Product/Process Change Notification

PCN#	Effective Date	Issue Date
2015-04-01C-03	2015/10/1	2015/4/1
PCN Classification	Product Category	
Major	Small Signal Switching	
Subject		
Changing lead frame		
Affected Product(s)		
BAV16P		
Description of Change(s)		
In order to enhance the effectiveness of the product, to achieve the better electrical conductivity of the copper lead frame		
Content of Change(s)		
Changing lead frame from Iron-nickel to copper		
Impact(s)		
N/A		
Attachment(s)		
Reliability Teat Report. SGS Report. MSDS Report.

Exterior comparison Chart

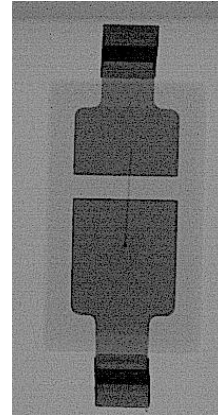
Original (Iron-Nickel)

New (Copper)
